KANSAS GAS AND ELECTRIC COMPANY

Subj: Quality Assurance Program Changes

Transmitted herewith are changed pages to the Wolf Creek Operating Quality Program described in the Wolf Creek Final Safety Analysis Report. The attached material also describes the reason for the change and the basis for concluding that the change does not reduce the KG&E commitments in the Operating Quality Program previously accepted by the NRC.

##### 17.2 QUALITY ASSURANCE DURING THE OPERATION PHASE

FIGURE 17.2-2  
KG&E ORGANIZATION FOR  
NUCLEAR OPERATIONS

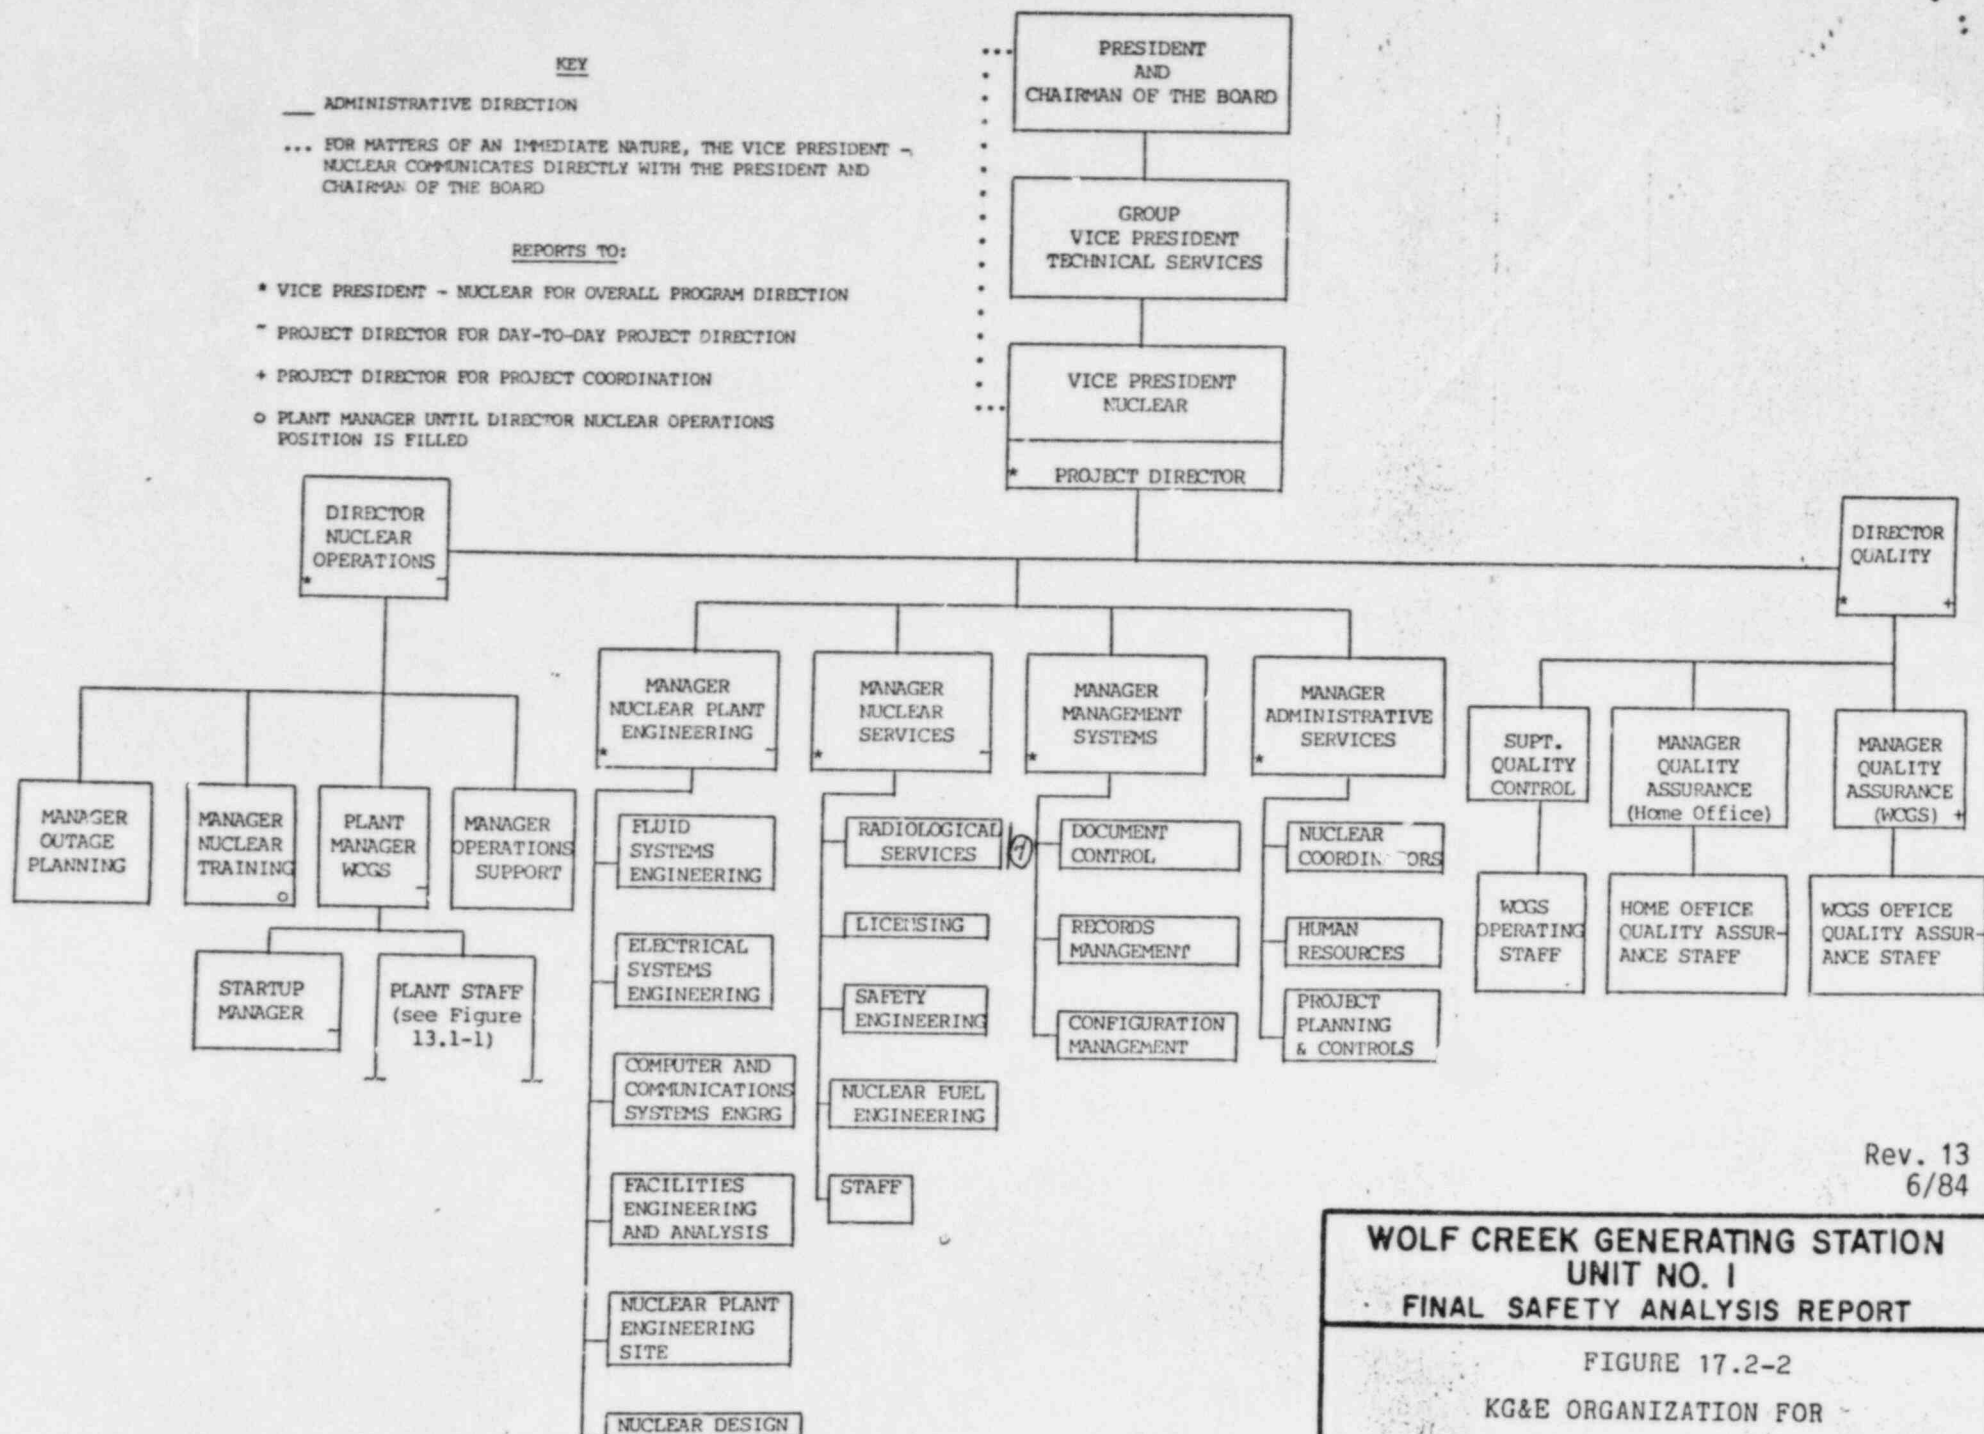
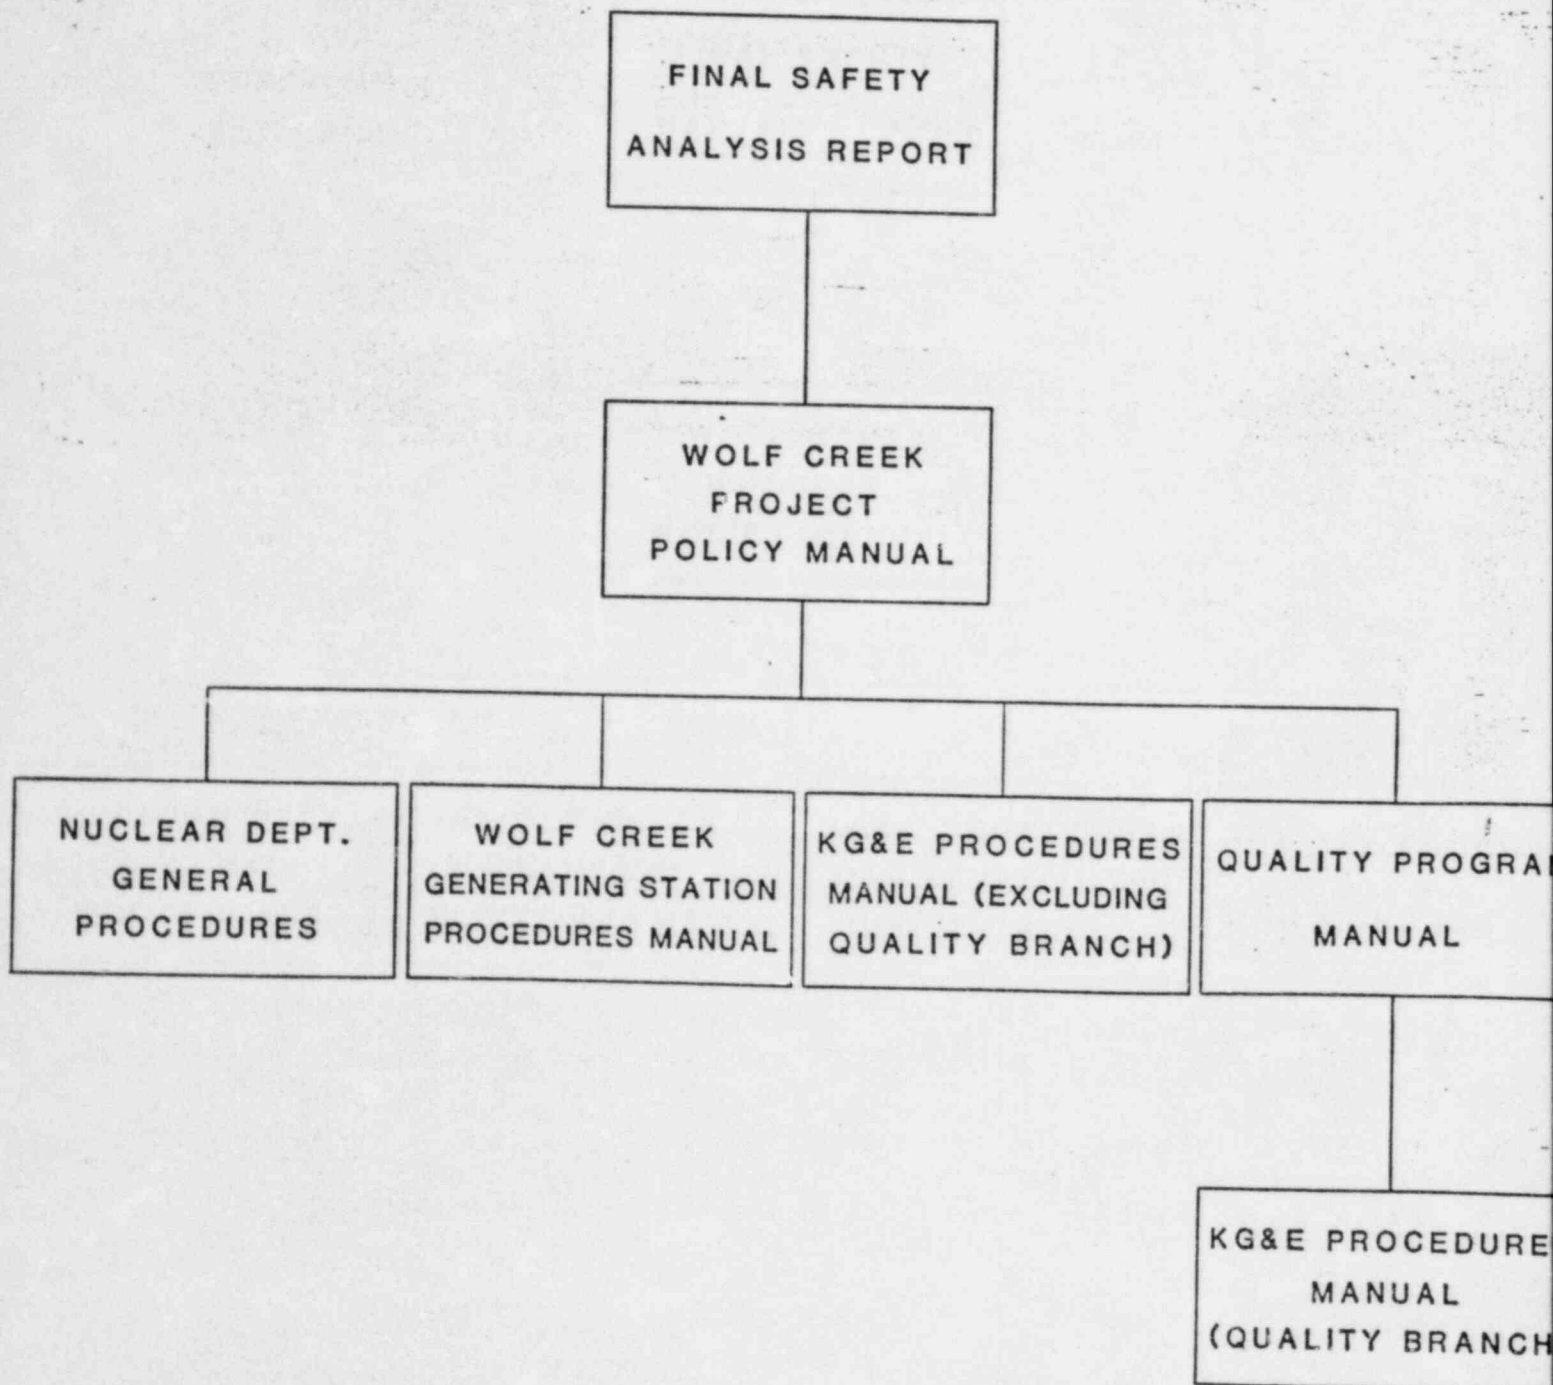
This change updates the division of responsibilities to be consistent with the revised organizational structure.

The revised text provides delineation of the authority and duties of positions performing quality functions. These organizational elements maintain sufficient authority and independence as required by Appendix B.
